Community Open House Summary - 2018 September 19

**PROPOSED REDESIGNATION OF
1703, 1707 & 1711 - 47 STREET SW**

WESTGATE MIXED USE DEVELOPMENT OPEN HOUSE - SEPTEMBER 19, 2018, 7PM

SUMMARY OF POSTED COMMENTS, VERBATIM

SHADOW STUDY

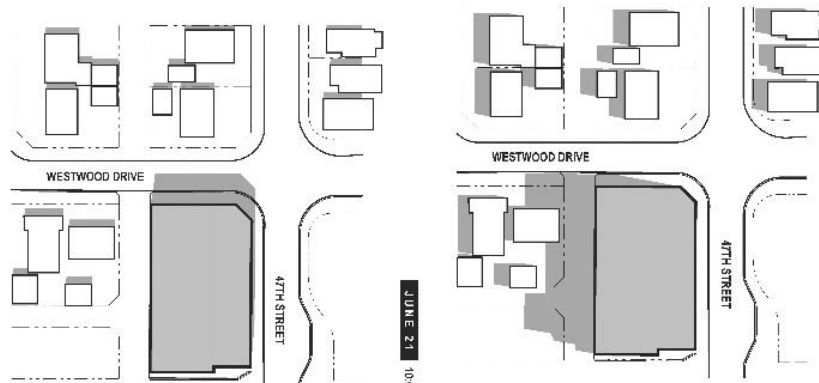
"Mixed Residential is not viable. Parking is already an issue. 3 Story Residential only would be fine with underground parking."
"Love the retail - no office - 3 floors of res."
"We feel a 3 storey building would be appropriate. Higher would create long shadows in winter months (Why was DEC. 21 not shown in shadow study)."
"General design is pleasing, but looks like we're trying to fit the biggest bldg possible. How about some breathing room? Green space?"
"Zone for 4 storeys only!!! 100% parking!!!"
"No office building"
"Residential housing no commercial office"
"We'd like to see condo not rented apartments"
"Keep this community more family orientated. Don't build 5 story small units - do 3 story larger family units"
"Residential only Please! Need retail, take the train!"
"Make it housing only. 3 storey."
"How about a row of townhomes?"
